Technical Service Bulletin

01 Engine does not start, rough running, excess moisture found in intake piping

01 13 04 2032958/1 June 6, 2013.

Model(s)	Year	VIN Range	Vehicle-Specific Equipment
A3 TDI	2010-2013	All	Not Applicable

Figure 1: Charge air cooler and intake hose layout

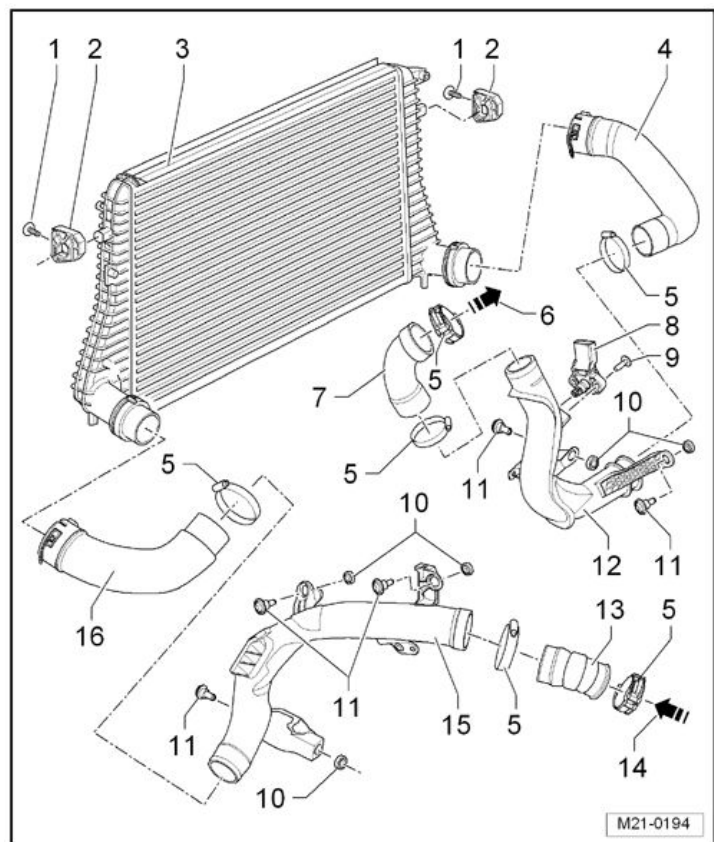
1. Lock carrier in service position. See *Repair Manual* >> *Group 50* in ElsaWeb.
2. Remove radiator and radiator fan assembly.
3. Separate A/C condenser from charge air cooler.
4. Remove the original charge air cooler (Figure 1, number 3) from the vehicle.

5. Remove the lower charge pressure hoses (Figure 1, numbers 4 and 16) and clean off any moisture or sludge. See *Repair Manual Group 21* >> *Turbocharger/G-Charger* >> *Description and Operation* >> *Component Overview* in ElsaWeb.
6. Remove cold side charge air pipe (Figure 1, number 12) and pressure hose to throttle valve (Figure 1, number 7).
7. Separate the A/C condenser from the charge air cooler.
8. Separate the charge air pressure sensor –G31– from cold side charge air pipe.

17. Install the revised charge air cooler (Figure 1, number 3) with regulating flap and connect the regulating flap vacuum hose.
18. Re-assemble all charge air pipe connections.
19. Connect A/C condenser to charge air cooler using fasteners from kit, and install radiator with fan assembly.
20. Reassemble front carrier.
21. Re-aim headlights.

Install revised charge air cooler kit **1K0198803B** to avoid the formation of this moisture in the boost system:

Figure 3: Routing the vacuum overlay harness

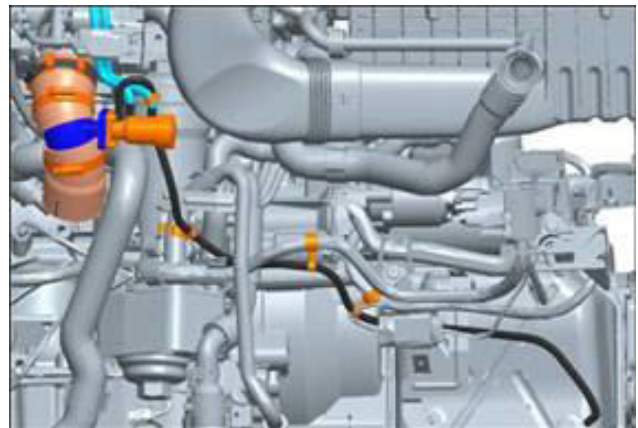
13. Route vacuum overlay harness (Figure 3, Figure 4).

Figure 7: The red arrow indicates where to cut vacuum source hose and install splice.

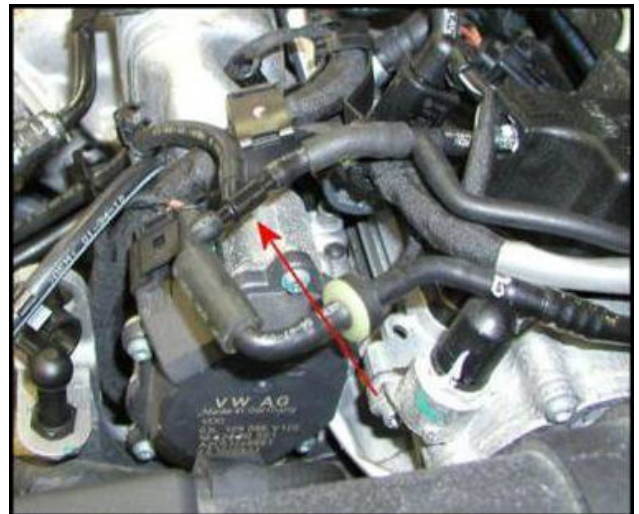
16. Cut vacuum source hose where indicated (Figure 7) and install splice.
